# Access Compliance Report

## Public Rights-of-Way

Intersection ID: 12728	Main Street: E_10TH_ST	Cross Street: SEIGLE_AV	Location: SW
ADA ID: 793BF8D16693	Ramp Type: PerpDiag	Initial Pass/Fail: Fail	Overall Compliance: No
		Severity Score: 10

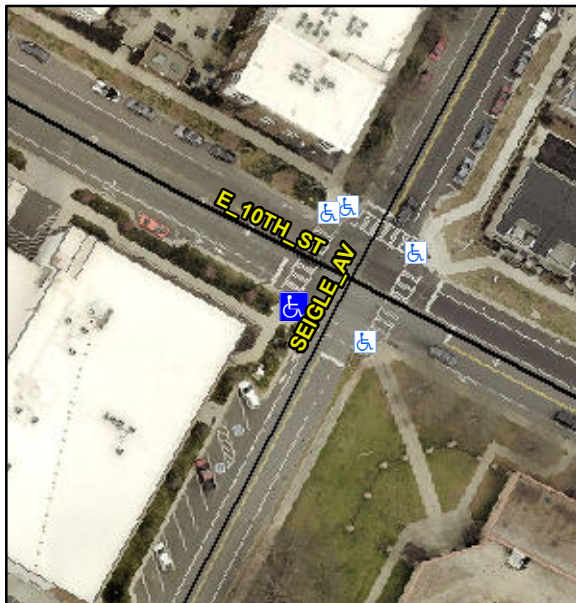
**R304.5.1, R304.5.3**

Compliance	Description	Data	Compliance	Description	Data
N/A	Ramp Length (in)	62.0	Yes	Ramp Slope (%)	6.3
No	Ramp Width (in)	47.5	No	Ramp XSlope (%)	3.4
N/A	Flare Type LT	N/A	N/A	Flare Type RT	N/A
N/A	Flare Slope LT (%)	N/A	N/A	Flare Slope RT (%)	N/A
N/A	Flare Traversable LT?	N/A	N/A	Flare Traversable RT?	N/A
N/A	Landing Length (in)	N/A	N/A	DWS Provided?	N/A
N/A	Landing Width (in)	N/A	N/A	DWS Contrast?	N/A
N/A	Landing Slope (%)	N/A	N/A	DWS Length (in)	N/A
N/A	Landing X Slope (%)	N/A	N/A	DWS Full Width?	N/A
N/A	Landing Curb? (Y/N)	N/A	N/A	DWS Offset (in)	N/A
N/A	Shared Landing?	N/A			
N/A	Gutter Ponding?	Yes	N/A	Gutter Slope (%)	N/A
N/A	Gutter Lip Ht (in)	N/A	N/A	Gutter X Slope (%)	N/A
N/A	Painted X Walk1?	Yes	N/A	Painted X Walk2?	Yes
	X Walk 1 Direction	To SE		X Walk 2 Direction	To NE
N/A	X Walk 1 Width (in)	89.0	N/A	X Walk 2 Width (in)	104.0
	X Walk 1 Slope (%)	6.2		X Walk 2 Slope (%)	2.0
	X Walk 1 X Slope (%)	2.2		X Walk 2 X Slope (%)	7.4

**Remove & Replace Curb Ramp With Two New Directional Ramps or Equivalent.**
